From: Barry Gibbs
Sent: Monday, August 08, 2016 1:23 PM
To: Cade Harris
Subject: FW: San Miguel B-North Haul Road
Attachments: HPSCANNER0394.pdf; HPSCANNER0395.pdf

I have attached copies of the road design and a typical design for drop structures associated with the road. The road and associated structures were approved as a part of the SMLM III permit renewal/revision.

| B-NORTH HAUL ROAD TYPICAL DETAILS | |

SAN MIGUEL ELECTRIC COOPERATIVE, INC.
SAN MIGUEL, LIGITE, MINE
PLAN AND PROFILE
AND SECTION B-NORTH
HAUL ROAD

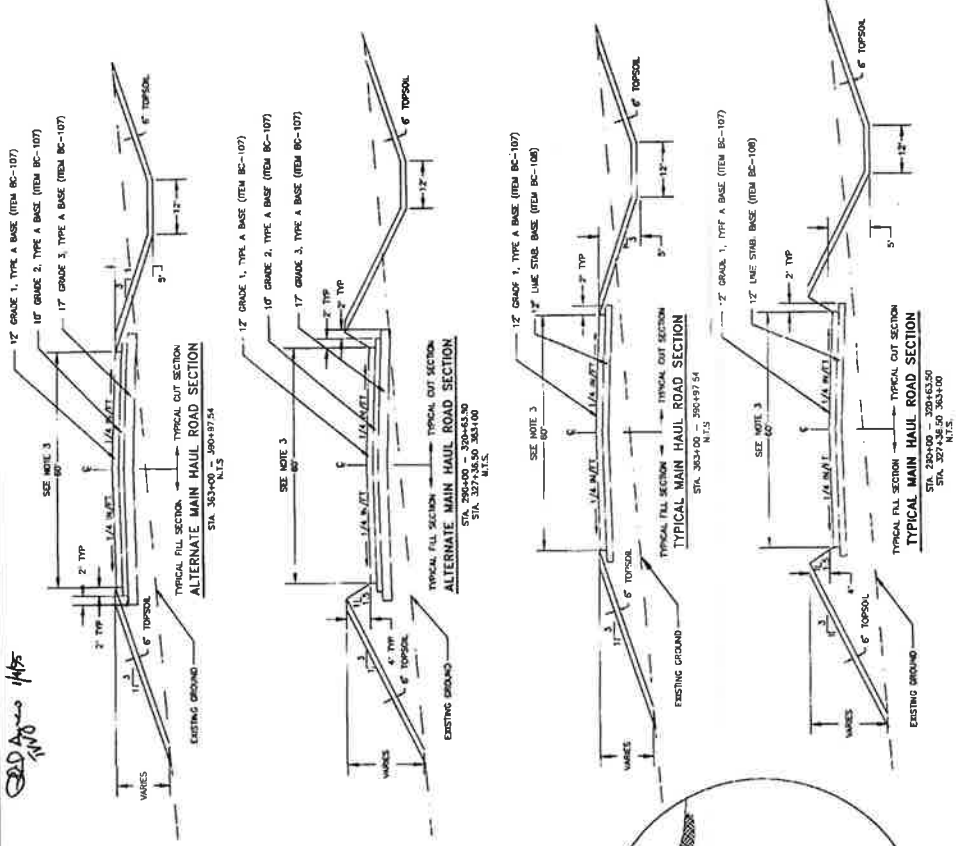
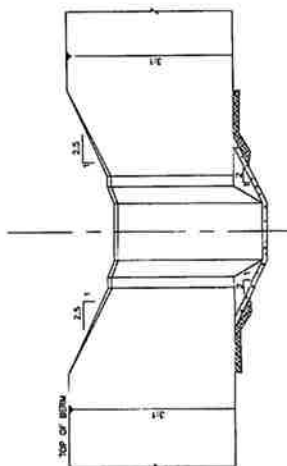
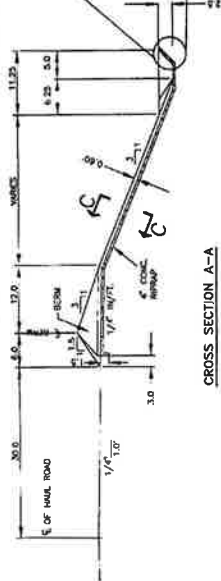
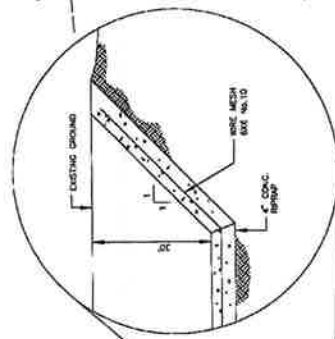
I've looked both documents over and have yet to find any mention of the where the drop structure is to be located. That is what I'm having trouble with, shouldn't the locations of any drop structures be shown on the plan and profile drawing or was this drop structure just built because they had a problem with runoff from the B-North Haul road. As you and I discussed it's a bad place for a drop structure without room for a supporting structure to hold the sediment.

So here's my question to you, I have no doubt that the drop structures installed were designed for somewhere on the B-North Haul road, but does a drop structures location on a primary road have to be shown on a map or can the mining company just put one in where they see the need as long as it is built to a typical design, or is there an

approval letter somewhere granting them permission to install the drop structure where it is installed?

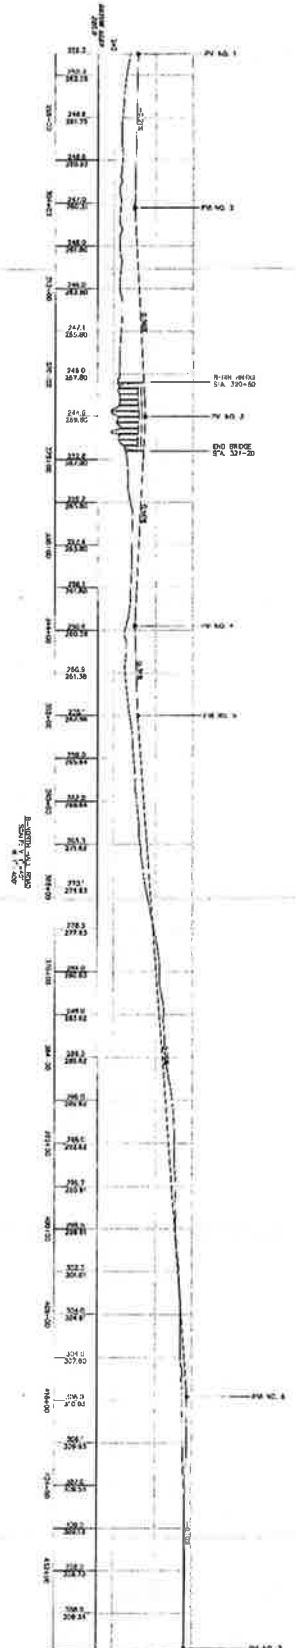
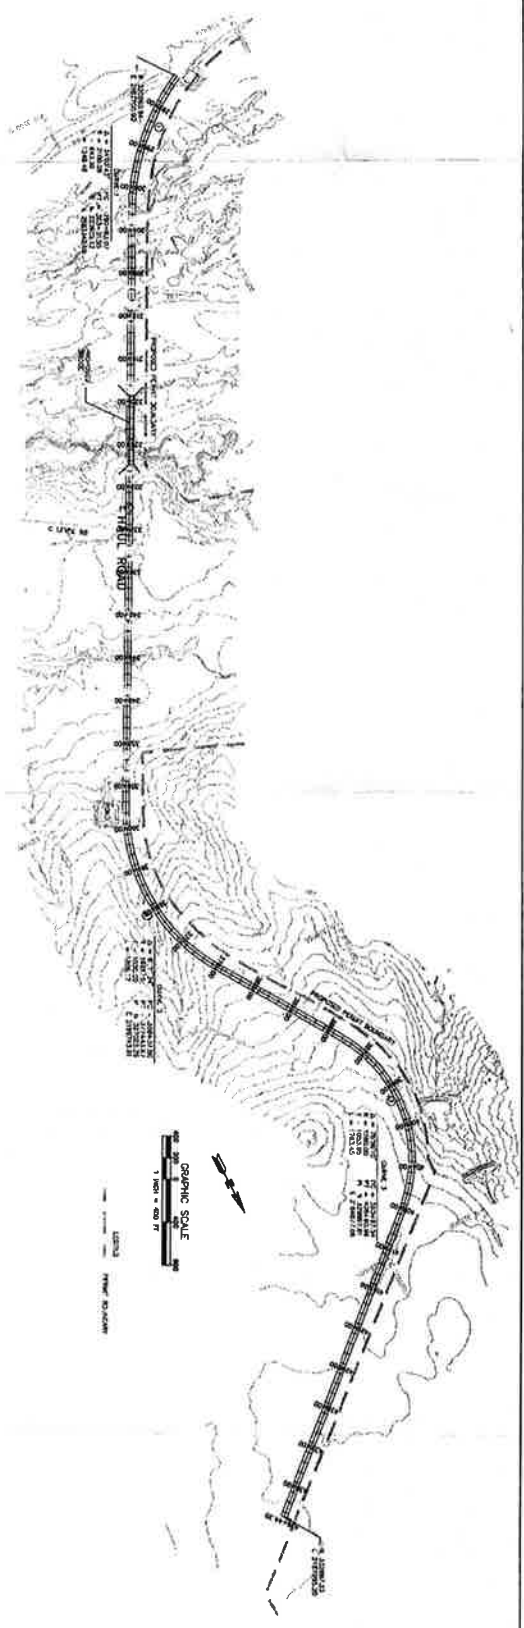
Robin, attached is the B-North Haul Road Plan and Profile showing the drop structure and location along the haul road. Note that the drop structure shown on the right side of the haul road (looking north) was not installed. I will also send you a scanned copy of the approval letter approving the entire package that included these particular items.

The design plans that he sent me were from 1993, I have attached them to this email and these are the same ones that you and I looked at in your office last week. One set shows plans for a typical drop structure on the B-North Haul Road and the other is the plan and profile of the B-North haul road, the B-North haul road plan and profile does not show any drop structure between Pond J and the Bridge going over LaParita creek.
